May 6, 2022 - ASWG Meeting #3

Project: Arlington Avenue Bridges	Date: May 6, 2022, 9 am
Topic: ASWG - Meeting #3	Location: Virtual - Microsoft Teams Conference Call

Arlington Avenue Bridges Aesthetic Stakeholder Working Group #3 PowerPoint Slides

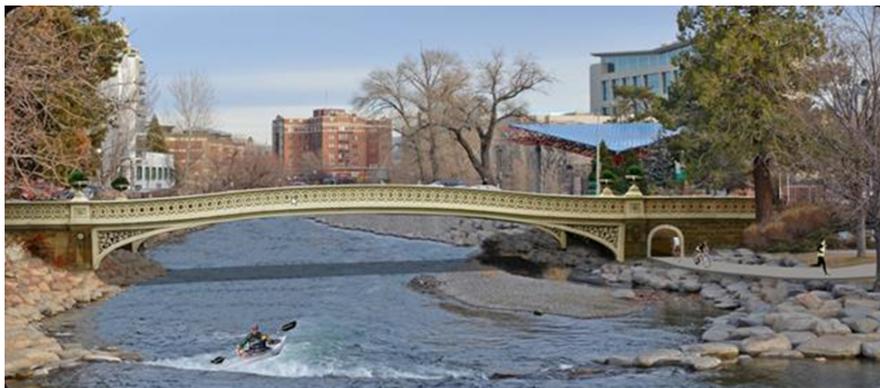
like the steps- still think overlook of 1/3rd length is not necessary- one could walk 10 yards either way and be at river walkway

It's how I get down there now when i am walking across bridge so steps makes sense. can shift util boxes a little but there is room generally.

Putting up my original idea in case it can still be in options:)
